ground floor plan

C P	SENIOR ARCHITECT (SZ) I MADRAS
W D	140, marshall's road, Egmore, madras 40 018
	drg no: SA (SZ) I TD 10/61. REV # 2
scale: 1:5	TYPE-II load bearing block
date: march '91	of 6 qtrs 3 storeyed.
file no:	
dealt: Janaki	ground floor plan.
subodh chand	A.G. John
asst. architect	architect
	S.F.B. Jasudian
	senior architect

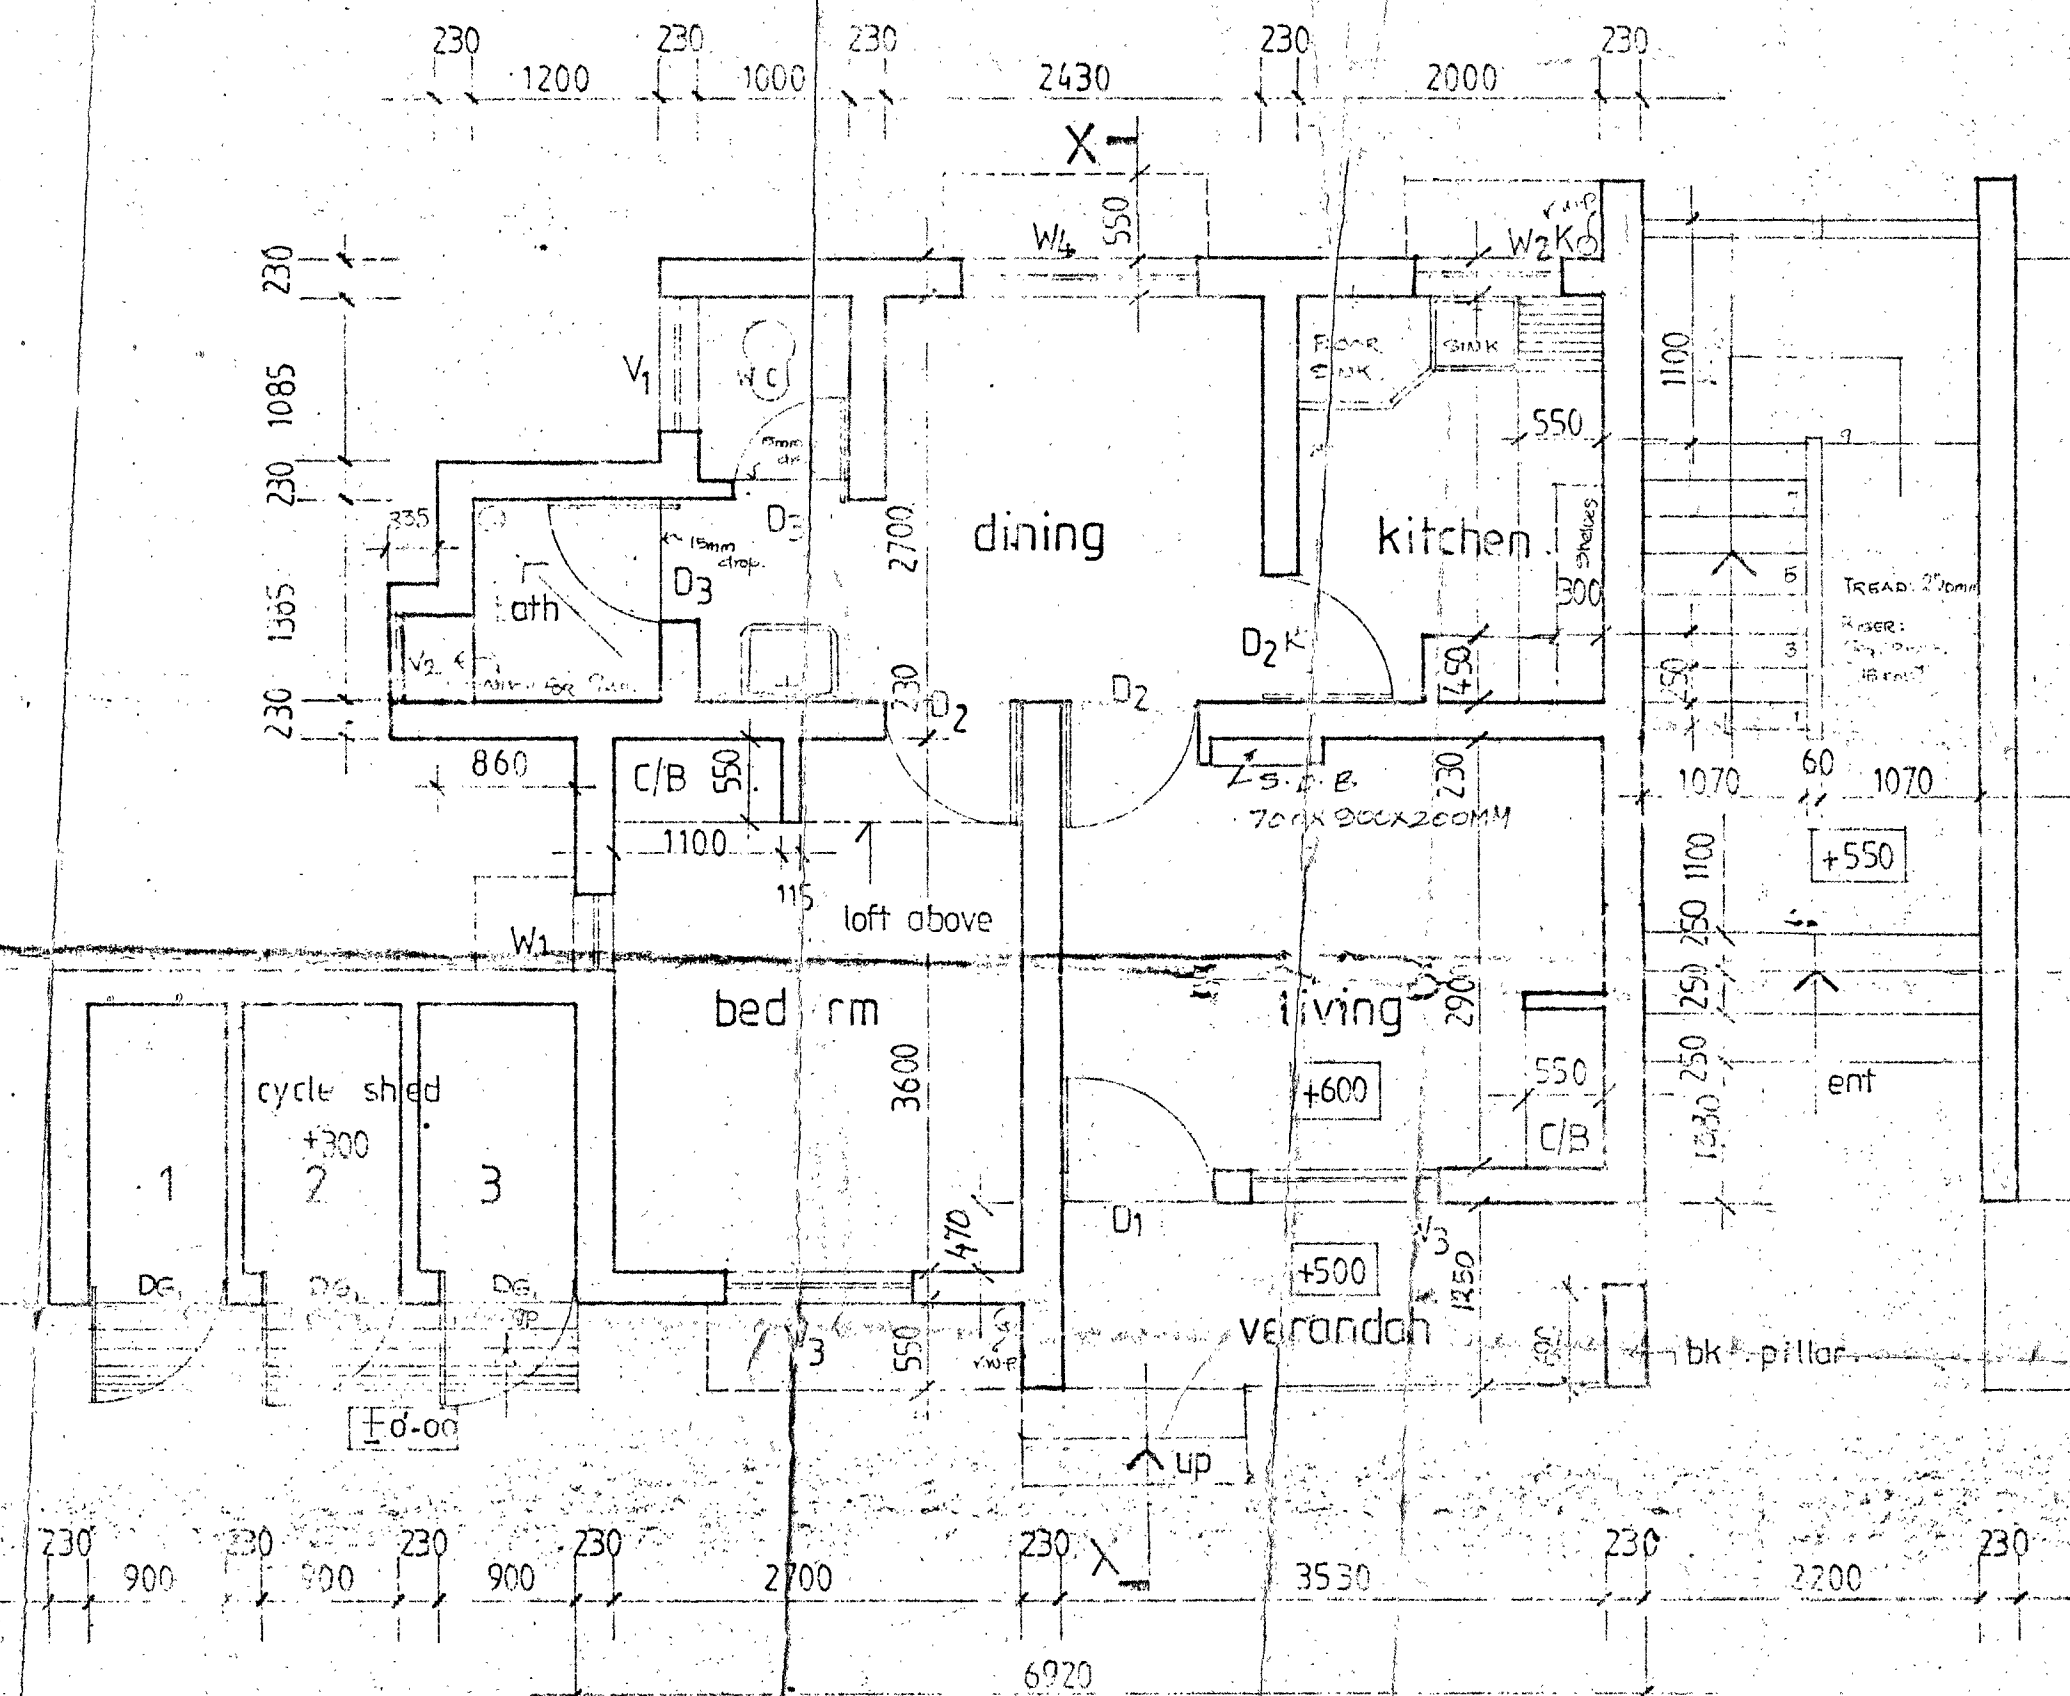
REVISION NO. 1
 ORIGIN: SA (SZ) I TD 10/61 DATED 20-7-1961
 THE POSITION OF S.P.B. HAS BEEN REVISED AS REQUIRED BY S.P.T.D. ENGINEER, MADRAS CENTRAL CIRCULAR VIDE HIS LETTER NO: DC/MC/191/2964 DATED 12-7-91.

REVISION NO. 2 DATED 19-8-91
 THE POSITION OF S.P.B. HAS BEEN REVISED AS REQUIRED BY S.P.T.D. ENGINEER, MADRAS CENTRAL CIRCULAR VIDE HIS LETTER NO: DC/MC/191/2964 DATED 12-7-91.
